SUBDIVISION REVIEW SHEET

CASE NO.: C8-2021-0205.0A

SUBDIVISION NAME: Resubdivision of Valley Side Heights Section One

**CITY OF AUSTIN –DEVELOPMENT SERVICES DEPARTMENT
SUBDIVISION APPLICATION – MASTER COMMENT REPORT**

FILE # 1434
SHEET 1 OF 3

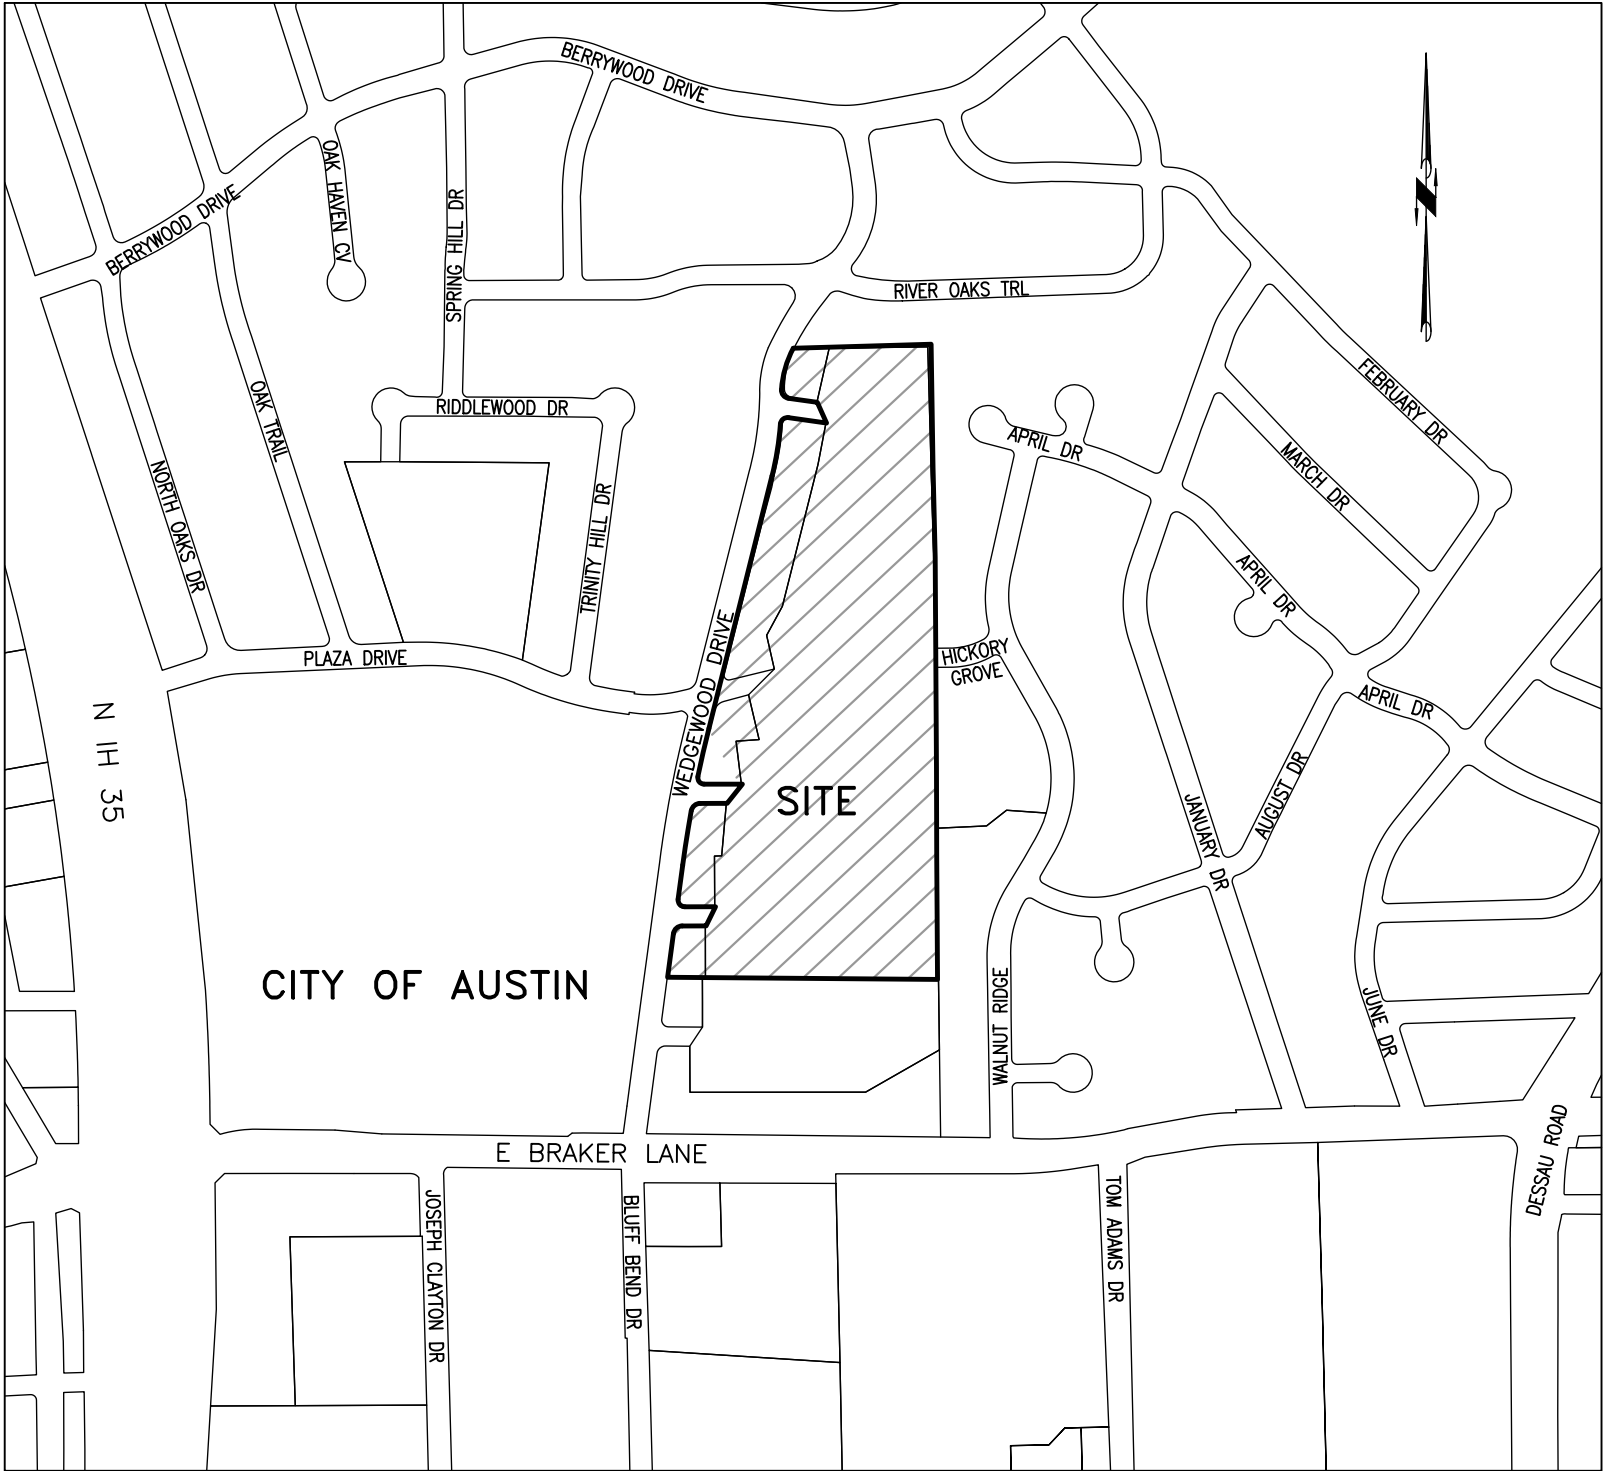
SR 2. On the cover sheet of the plat, remove the reference to multi-family use below the lot information table.

FILE # 1434
SHEET 2 OF 3

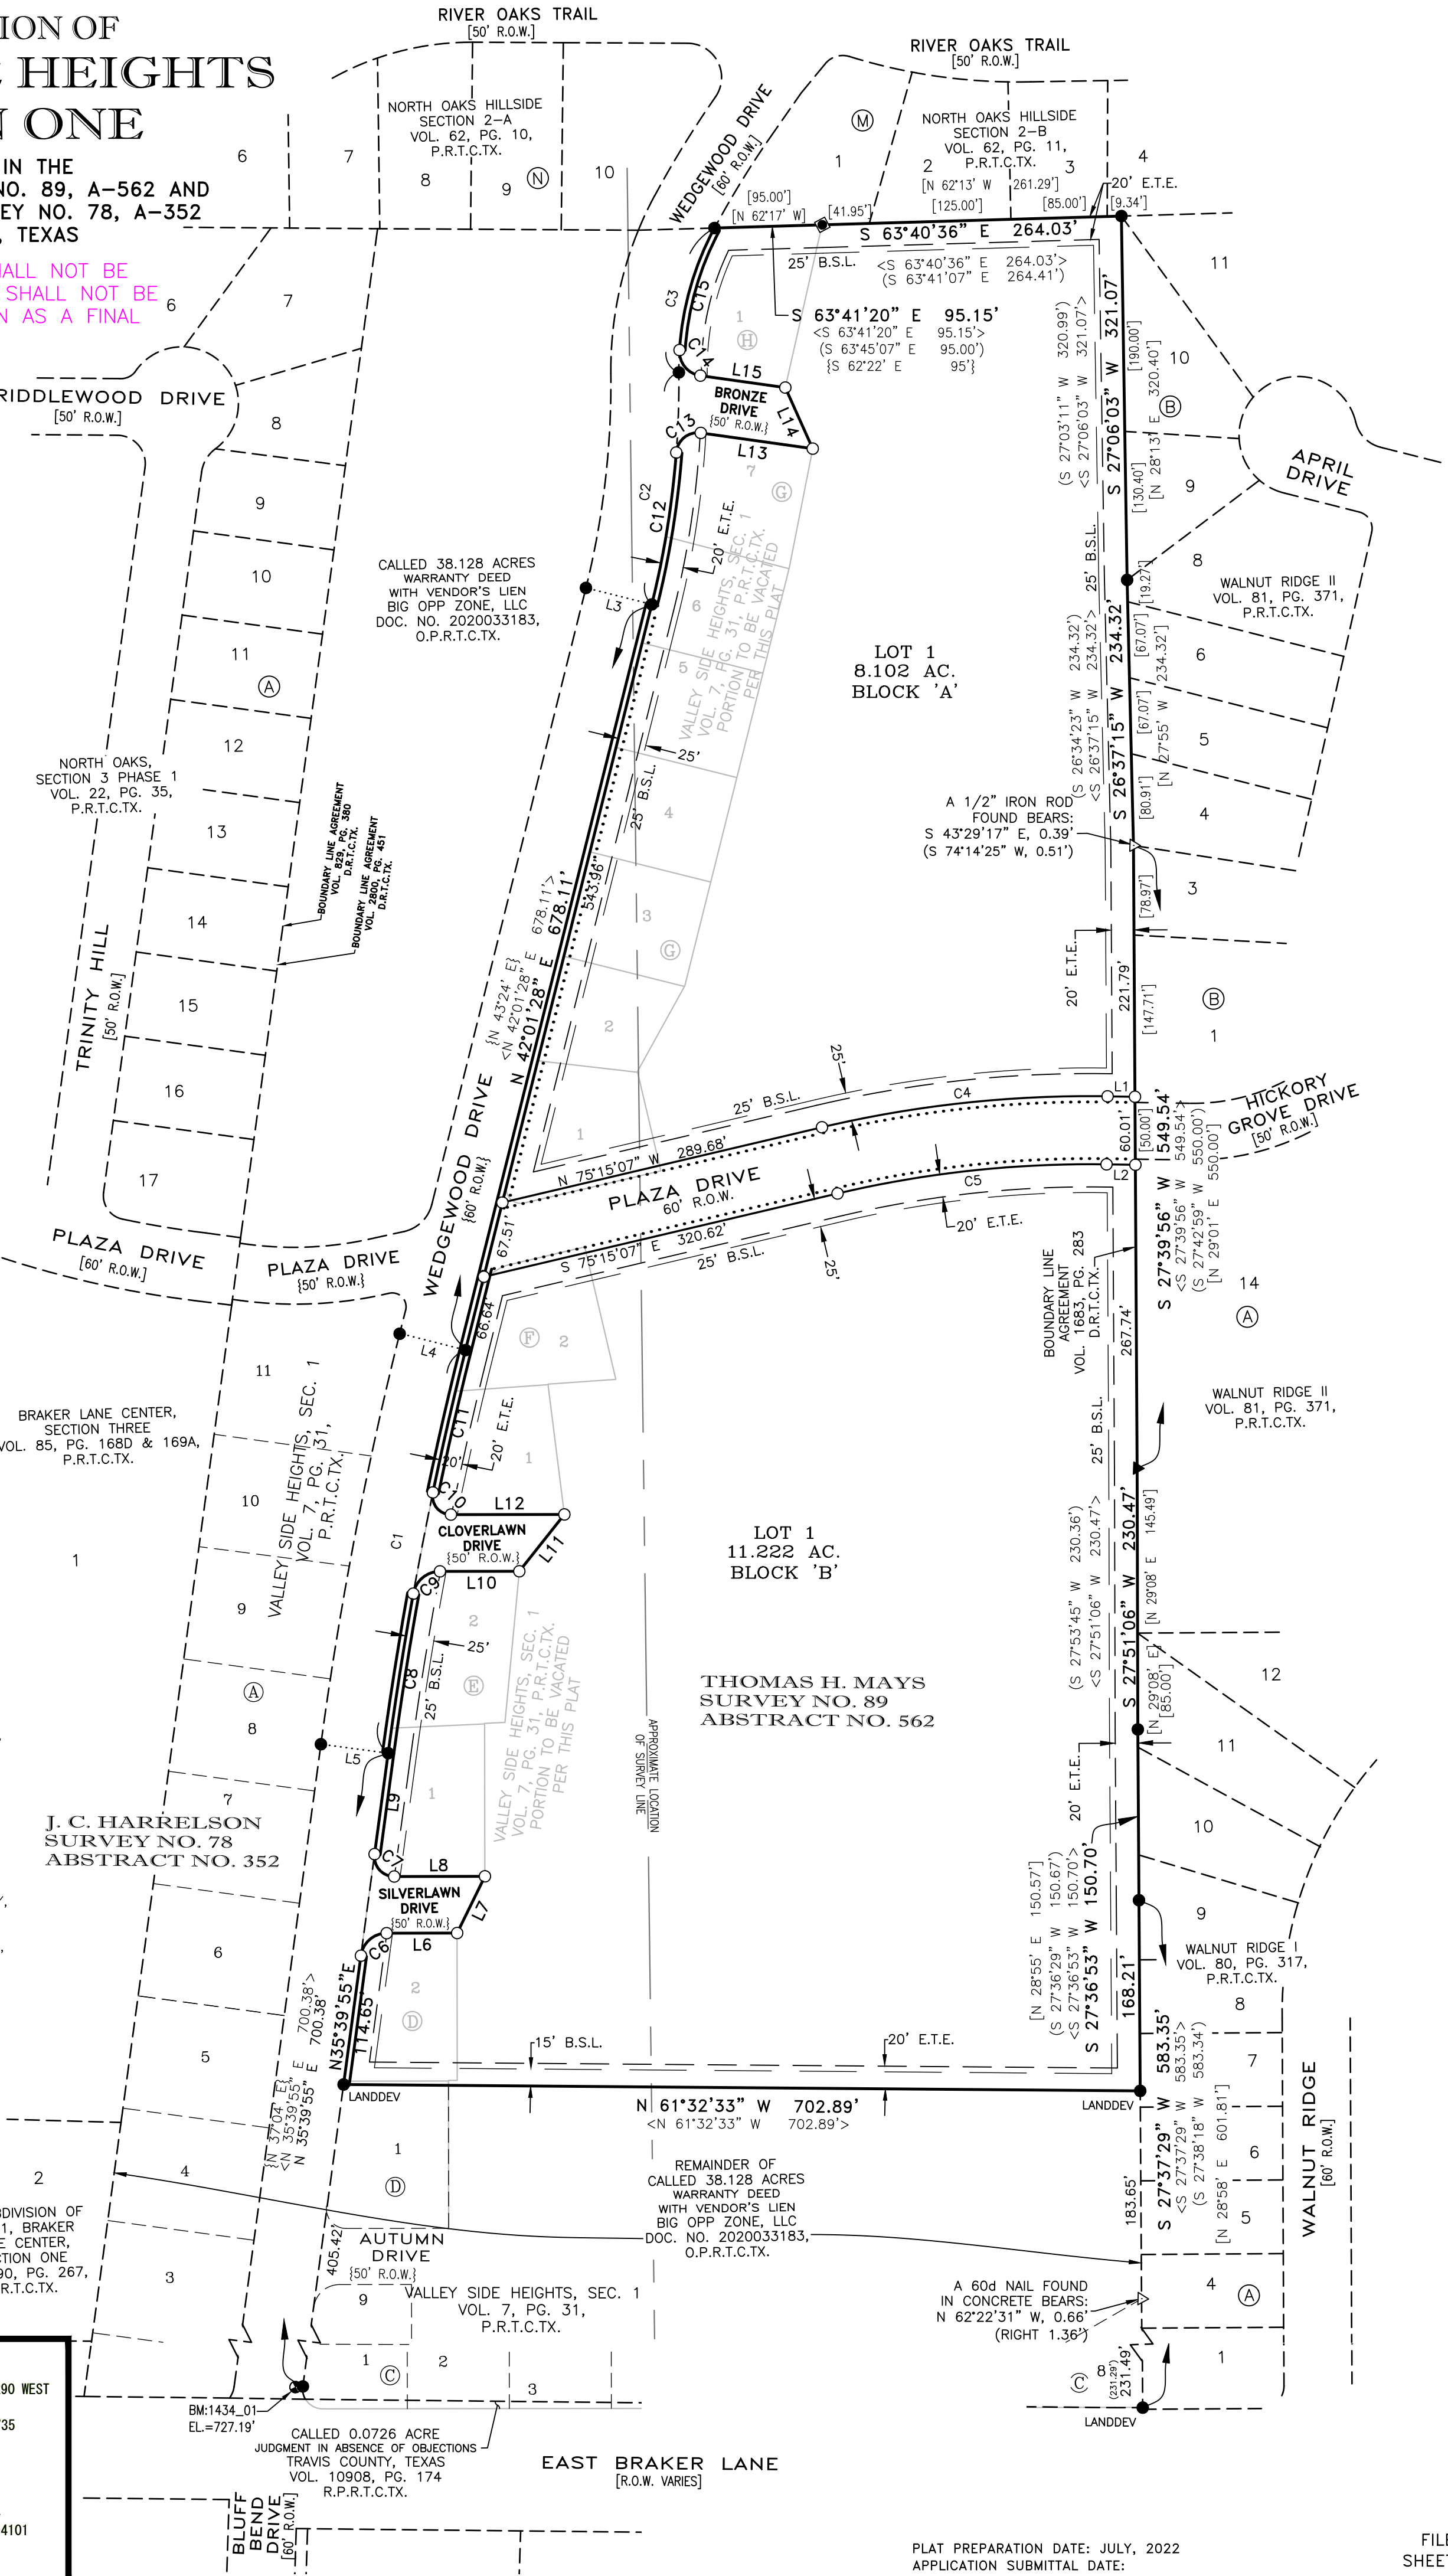
SR 4. On Sheet 2 of the plat, remove the original lots and block, as well as the survey line from inside the proposed lots. 25-1-83, 30-1-113:
